TM 11-6625-274-35

TEST SETS, ELECTRON TUBE TV-7/U,
TV-7A/U, TV-7B/U, AND TV-7D/U

CHANGE }
No. 5 }

CHANGE }
No. 4 }

Figure 44(2). Test Set, Electron Tub TV-7D, schematic diagram (sheet 2).

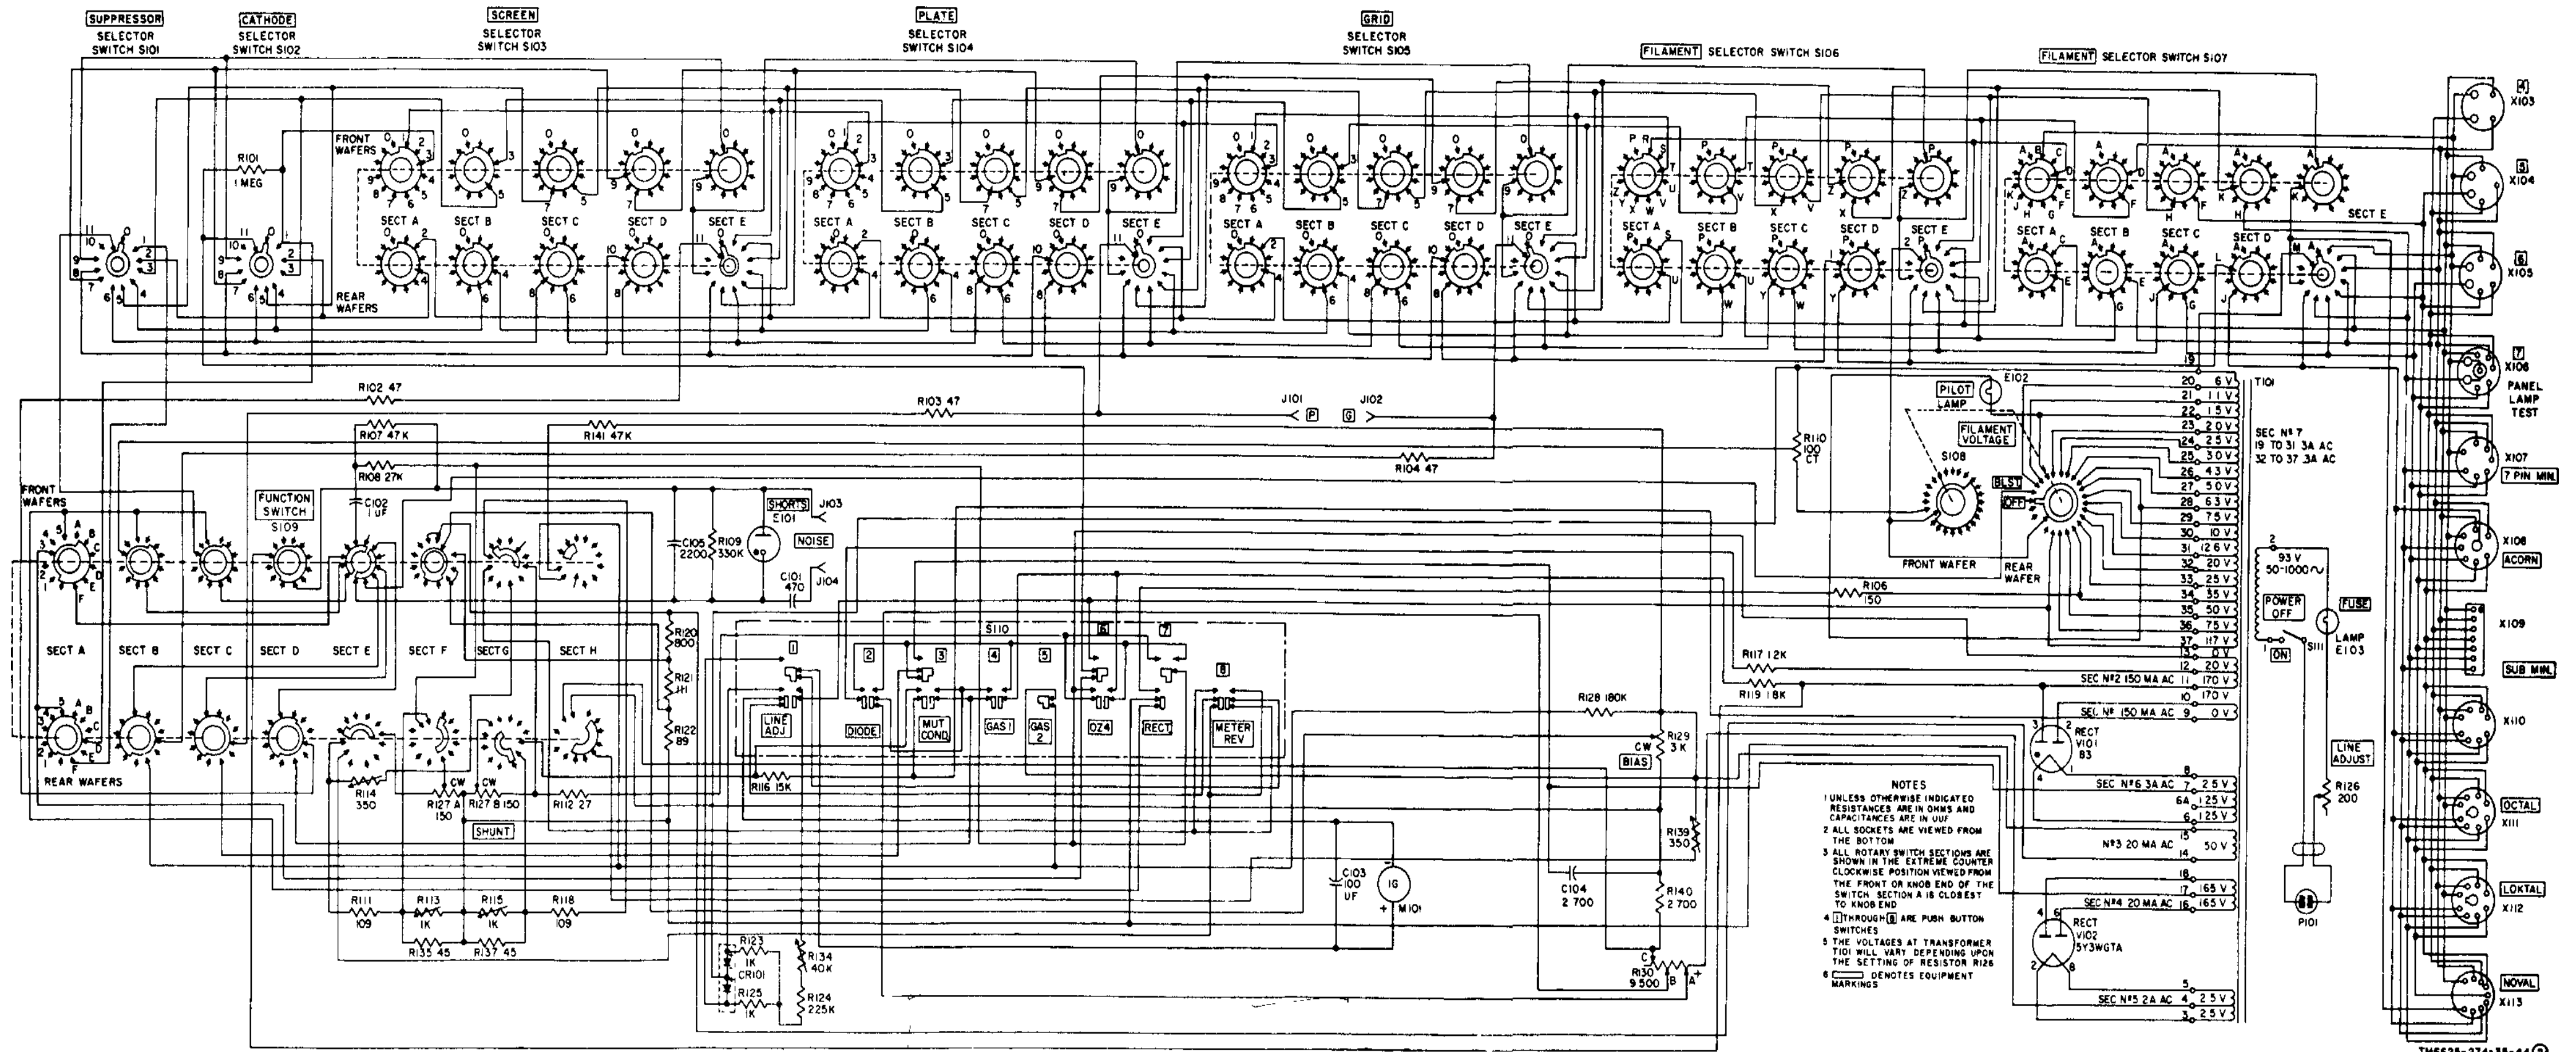
Figure 44② (sheet 2), switch S109, section F. Delete the connection between contacts D and E and substitute 2 connections between C and E.
